Subject: RE: Town of Dewey Beach -- Dewey Code about driveway entrances -- question

The town is looking into a possible conflict (with another subject in our code) concerning LOTS / Parcels and driveway entrances.

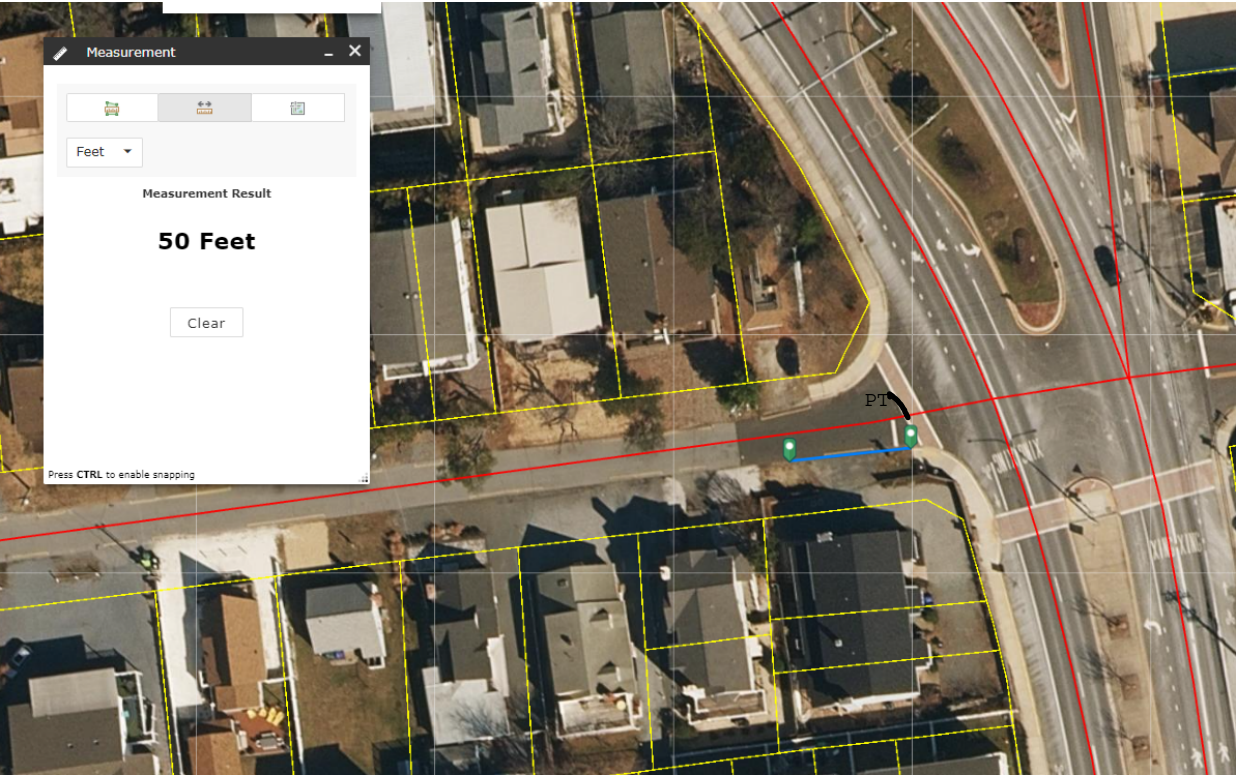
initials PT stand for?

Typically we view the entrance spacing from an intersection from the PT of the intersection (see example in pic below). The state regulation is 40' from the PT (see reg below). However, the language reads where feasible. In Dewey's circumstance, we would push the entrance as far away from the PT as possible.

Point of Tangent. It's the point where the radius ends and the road turns straight.
